Variation of Condition of NYM2007/0143/FL to Replace Glazing to 4no. South Facing Windows with Clear Glass in Annexe at Rose Lea, Egton.
Your Ref: NYM2008/0438/FL

Further to your letter dated 26 June 2008 please find enclosed four copies of the revised proposals, dwg. no. W/E/10/03 rev C

ROSE LEA ~ EGTON

- SCHEME ▣ GUNNISON & CO ARCHITECTS/FORMANNA
- CLIENT ▣ MR BRATHWAITE
- DRAWING ▣ SCHEME PROPOSAL 1 S
- DWG. NO. ▣ W/E/10/03 RFA (10/07)
- SCALE ▣ 1:100 REB (WATSON)
- DATE ▣ JAN 07 REVC (JUL 08)
- DRAWN ▣ MALCOLM WATSON
- TEL No. ▣ 01947-895457

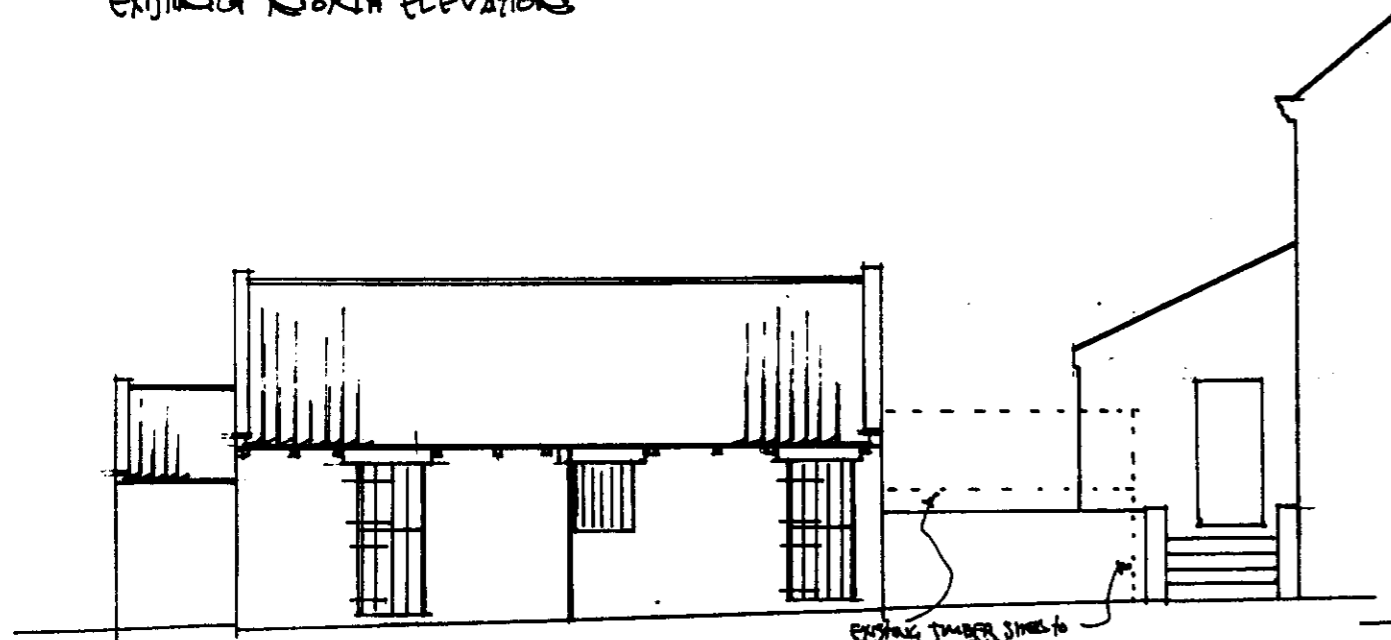
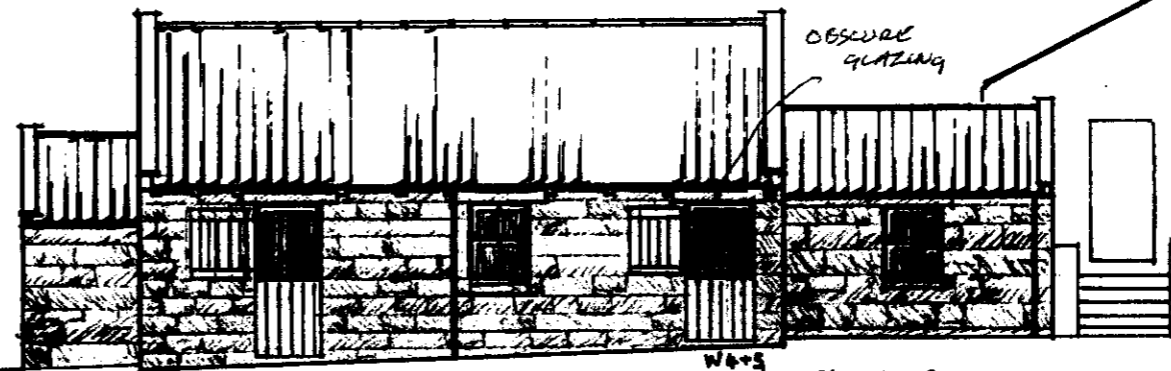
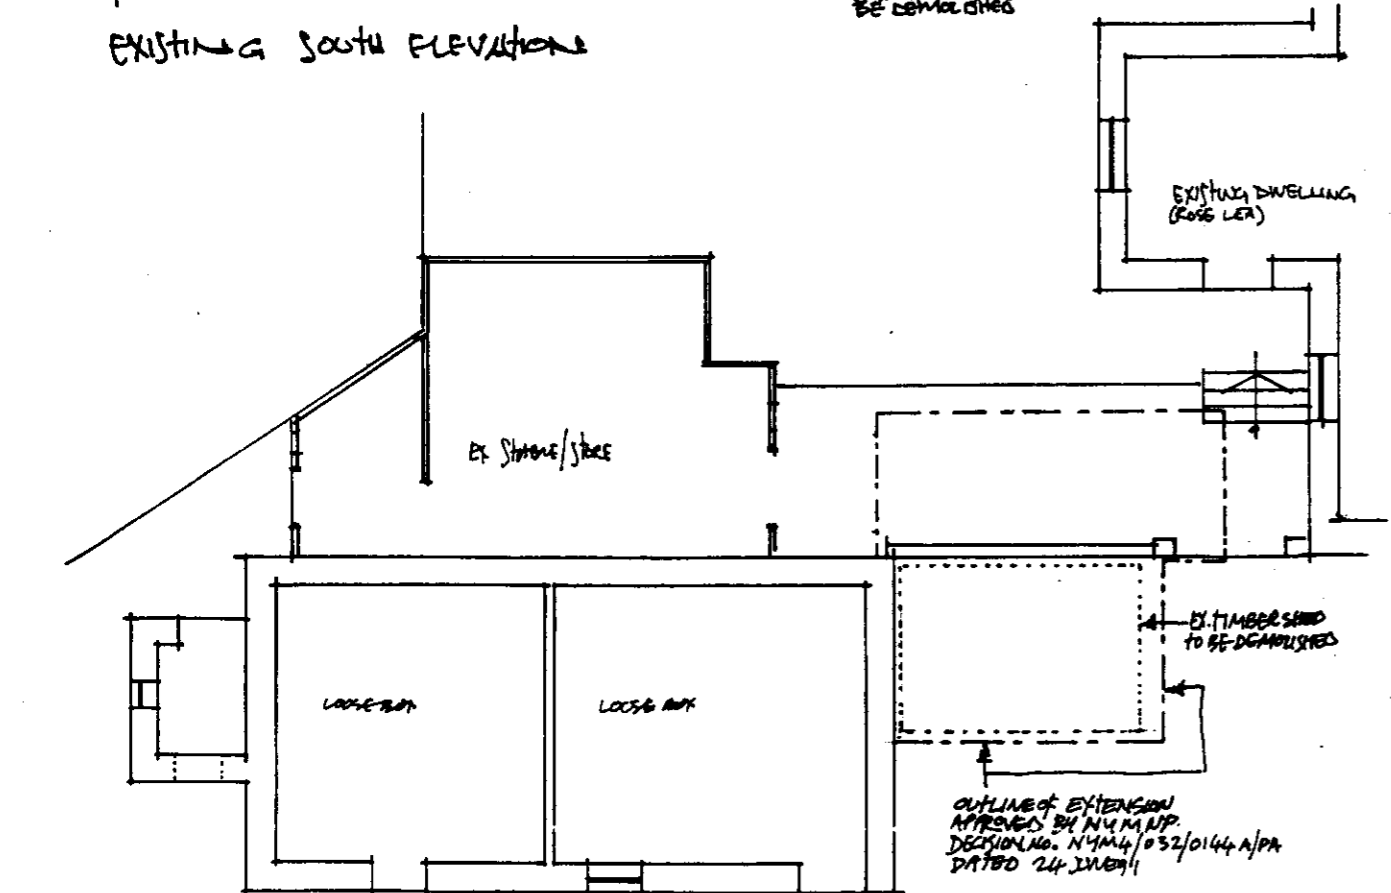
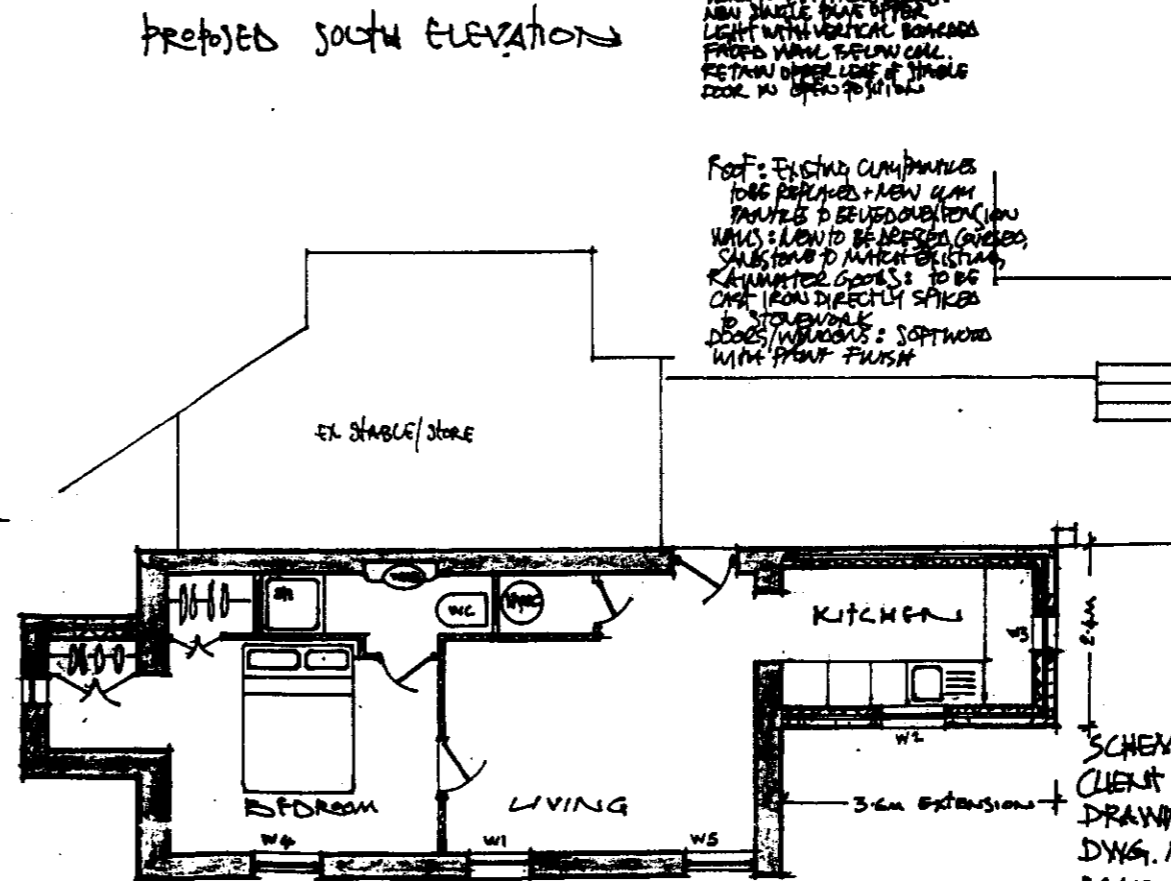
The revisions include the addition of obscure glazing to Window 5 and the setting back of window frames from the face of the structure by 75mm.

With regards to the position of the frame within the reveal, no improvement is actually achieved in reducing the angle of view out. Reduction is achieved by the actual depth of the reveal to the wall, in this instance with the addition of the internal dry lining, the reveal will be 475mm.

→ Superseded by a phone conversation later the same day where Mr. Watson agreed to a 100mm reveal depth.
